ADDENDUM NO. #1
ISSUE DATE: December 11, 2023

**RE: SCHOOL OF EDUCATION
MULTI-BUILDING CLASSROOM RENOVATION – ASBESTOS ABATEMENT
UNIVERSITY OF WISCONSIN
MADISON, WISCONSIN**

UW Madsion Project No. **0679-2215** / UWSA Project No. **A-22-013**

1 THIRD FLOOR ASBESTOS ABATEMENT PLAN
1/4" = 1'-0"

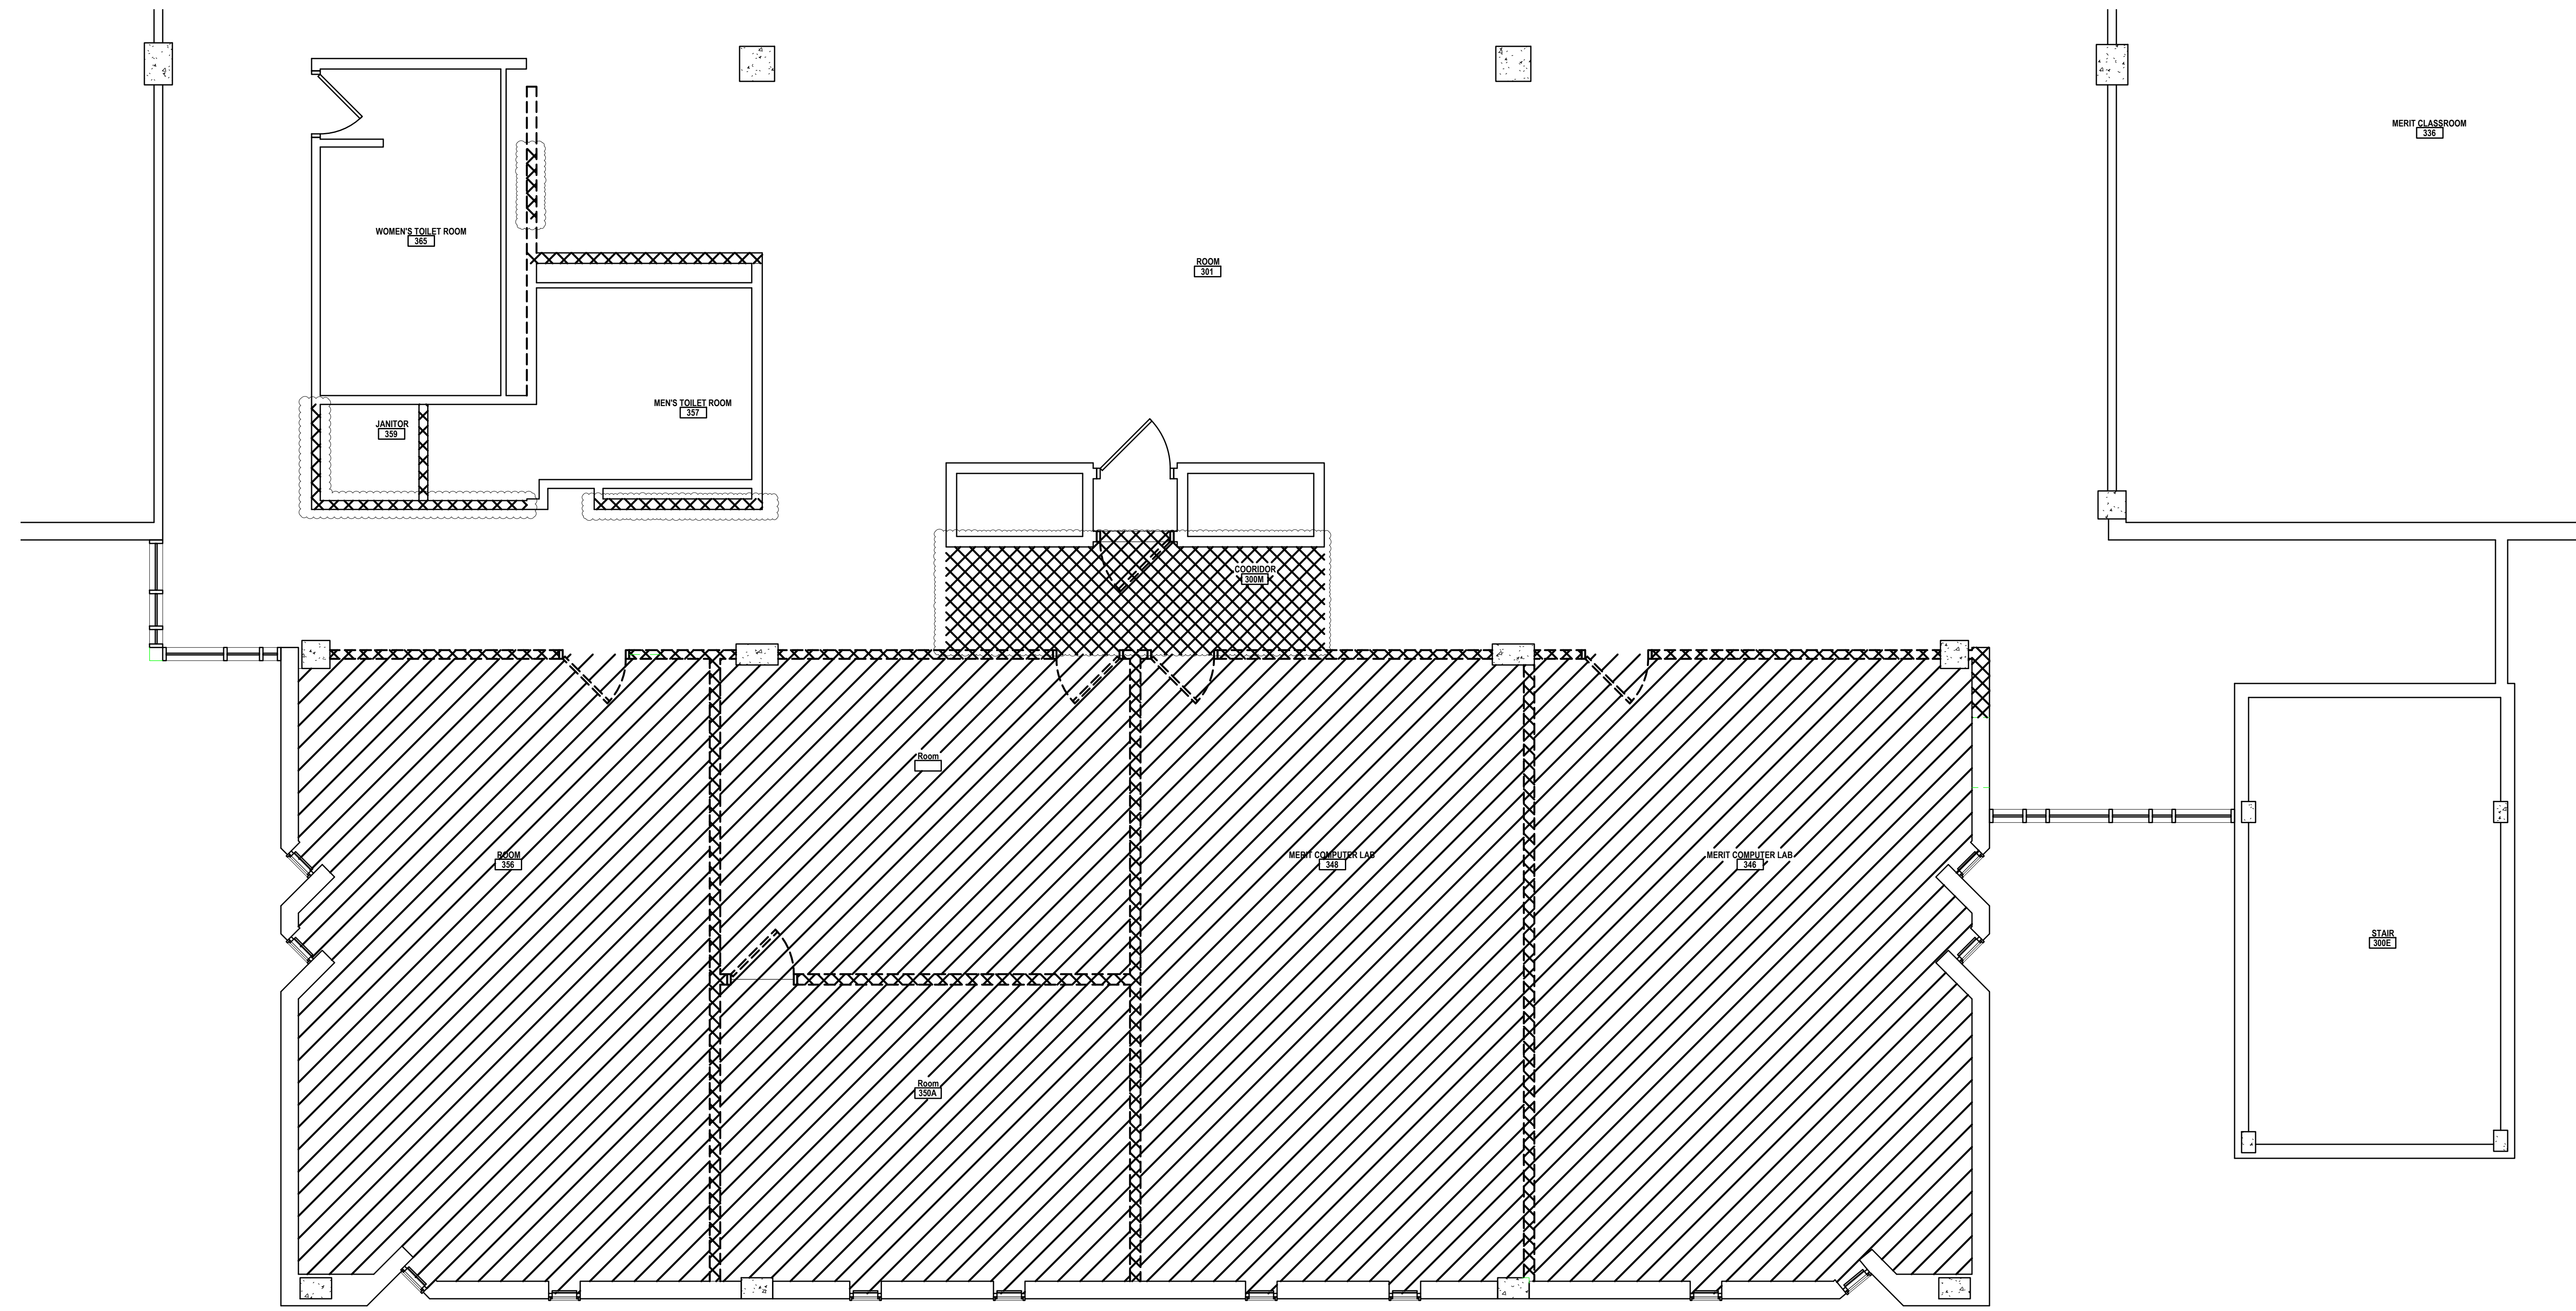
4. Sheet H203 – THIRD FLOOR ABESTOS ABATEMENT PLAN
 - a. Replace sheet H203 in its entirety with the attached revised sheet H203.
 - i. Add demolition of ceiling at Corridor 300M.
 - ii. Add demolition of walls at Janitor Room 359 and Men’s Toilet Room 357.
 - iii. Modify extent of demolition of east wall of Women’s Toilet Room 365.
5. Sheet D203 – THIRD FLOOR DEMOLITION PLAN
 - a. 1/D203 Third Floor Demolition Plan: Add Demolition Key Note 36 in Room 350 near the North wall.
 - b. Revise Demolition Plan Key Note 2 to read: “Remove 3 5/8” metal studs. Removal of GWB coated with asbestos containing texture, both sides, by State Abatement Contractor. Refer to. Refer to H203.”

- c. Revise Demolition Plan Key Note 3 to read: “Remove 3 5/8” metal studs and 1 1/2” sound attenuation blanket. Removal of GWB coated with asbestos containing texture, both sides, by State Abatement Contractor. Refer to H203.”

- d. Revise Demolition Plan Key Note 15 to read: “Remove metal studs. Coordinate with MEP. Removal of GWB coated with asbestos containing texture, one side, by Abatement Contractor. Refer to H203. Coordinate with MEP.”

- e. Revise Demolition Plan Key Note 33 to read: “Remove 3 5/8” metal studs, ceramic wall tile (height 5’-0”), one side, and 1 1/2” sound attenuation blanket. Removal of GWB coated asbestos containing texture, both sides, by Abatement Contractor. Refer to H203.”

- f. Add Demolition Plan Key Note 36: “Demo casework in its entirety, approx.15’-6”in length.”
- g. Add Demolition Plan Key Note 37: “Demo suspension system of GWB ceiling. Removal of GWB coated with asbestos containing texture by Abatement Contractor. Refer to H203.”
